Response to Information Request – Development Application for a Development Permit for a Material Change of Use for Medium Impact Industry (storage yard) and Transport Depot at 93 Bukulla Street, Wacol QLD 4076 and described as Lot 13 on SP132727.

BCC Ref: A006934383

We refer to Council's Information Request dated 4 February 2026. On behalf of the applicants, Bukulla Holdings Pty Ltd and Marble Logistics Pty Ltd, please find below responses to each of the Information Request items, which have been reproduced in italics below.

Figure 1: proposed non-prejudicial future bikeway corridor configuration.

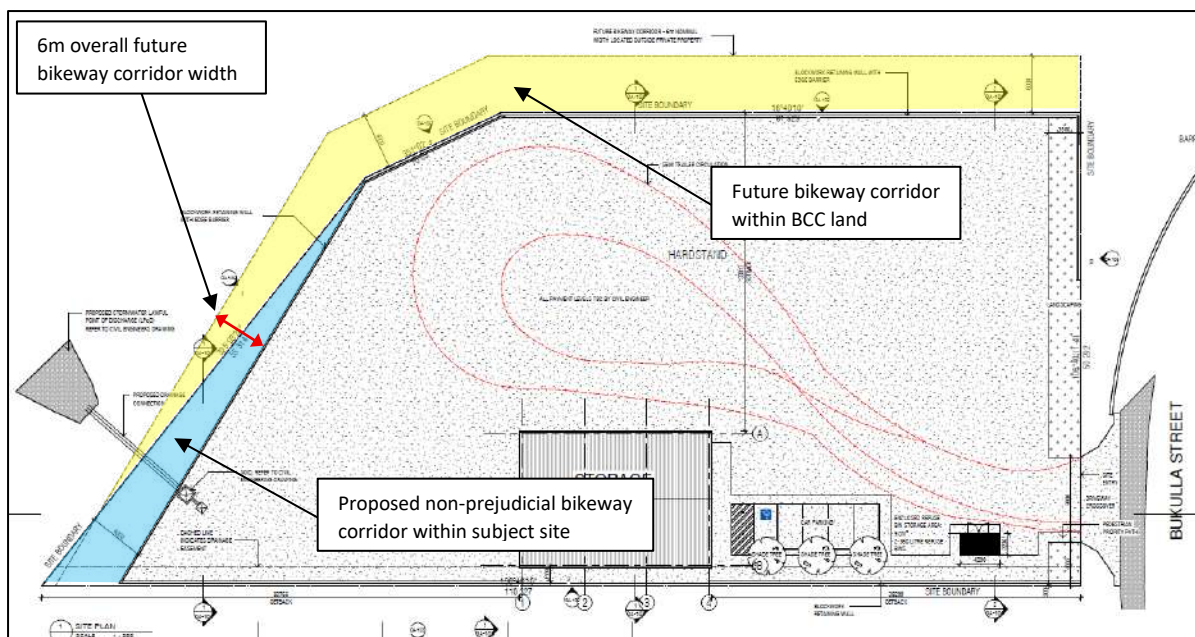
- 1) A secondary cycle route is identified within the subject site. The development must not prejudice the future 6.0m wide road reserve along the rear of the site for a future shared bike path. The alignment of the cycle route should be positioned to tie in with the 6.0m wide cycle corridor conditioned under development approval A005856803. Amended plans must ensure that structures and improvements for the proposed development do not conflict with the 6.0m wide no-to-prejudice area. Retaining walls must be outside this area. Drainage pipes crossing this area can be accepted where under existing levels.***

Please refer to the attached proposal plans and civil siteworks concept plans, which have been amended to provide a tapered non-prejudicial area which is able to accommodate a future cycle route. This will have a dimension of 6.0m at the eastern boundary of the site and will progressively taper to nil at the truncated corner at the western boundary of the site.

This will integrate with the future bikeway corridor component within Council land, to provide a 6.0m wide overall corridor width along the rear boundary interface. This arrangement will integrate with the comparatively unconstrained corridor on the western side of the site and rear boundary where clearing has historically occurred and a slashed grass corridor is maintained, compared to areas toward the eastern side of the rear boundary. A plan extract is provided in figure 1 below.
